# Access Compliance Report

## Public Rights-of-Way (Curb Ramps)

Intersection ID: 20390	Main Street: OLD_PINEVILLE_RD	Cross Street: GREENHILL_DR	Location: NW
ADA ID: 5BADD6D4E2B4	Ramp Type: Directional1	Initial Pass/Fail: Fail	Overall Compliance: No
Severity Score: 13.75			
Codes/Mitigation Info/Possible Solution		Field Measurements/Component Compliance

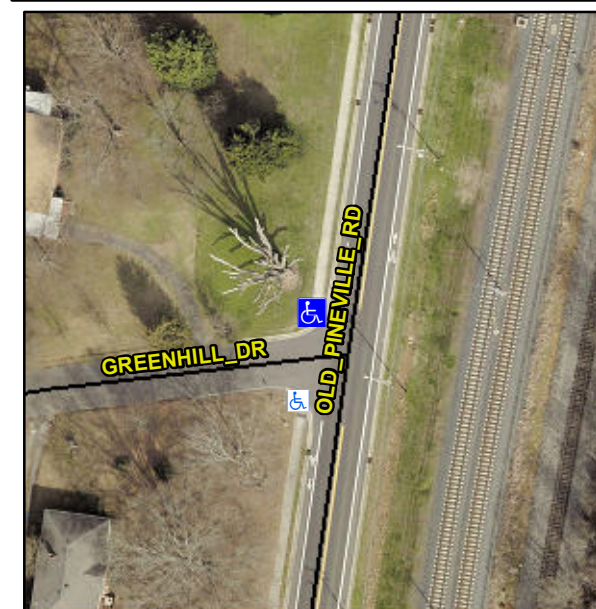
**R304.2.2, R304.5.3**

Compliance	Description	Data	Compliance	Description	Data
N/A	Ramp Length (in)	97.0	N/A	Grade Break?	N/A
Yes	Ramp Width (in)	67.0	N/A	Grade Break Slope (%)	0.0
No	Ramp Slope (%)	10.4	N/A	Grade Break XSlope (%)	0.0
No	Ramp XSlope (%)	2.3			
N/A	Flare Type LT	N/A	N/A	Flare Type RT	N/A
N/A	Flare Slope LT (%)	N/A	N/A	Flare Slope RT (%)	0.0
N/A	Flare Traversable LT?	N/A	N/A	Flare Traversable RT?	N/A
N/A	Landing Length (in)	0.0	N/A	DWS Provided?	N/A
N/A	Landing Width (in)	0.0	N/A	DWS Contrast?	N/A
N/A	Landing Slope (%)	0.0	N/A	DWS Length (in)	N/A
N/A	Landing X Slope (%)	0.0	N/A	DWS Full Width?	N/A
N/A	Landing Curb? (Y/N)	N/A	N/A	DWS Offset LT (in)	N/A
N/A	Shared Landing?	N/A	N/A	DWS Offset RT (in)	N/A
N/A	Gutter Ponding?	0.0	N/A	Gutter Slope (%)	N/A
N/A	Gutter Lip Ht (in)	0.0	N/A	Gutter X Slope (%)	N/A
N/A	Painted X Walk1?	No		Road Slope (%)	1.9
	X Walk 1 Direction	To S		Road X Slope (%)	10.2
	X Walk 1 Width (in)	N/A		Clear Space?	N/A

X Walk 1 Slope (%)	1.9	N/A	Clear Space to XWalk (in)	N/A
	X Walk 1 X Slope (%)	10.2	N/A	Storm Grate/Utility Hazard?	N/A
N/A	Ramp inside XWalk1?	N/A		Storm Grate/Utility Type	
N/A	Any Obstructions?	N/A			N/A
	Obstruction Type		Yes	Surface Condition? (G/P)	Good
			N/A	Curb Slope (%)	11.0

**Remove & Replace Entire Ramp.**
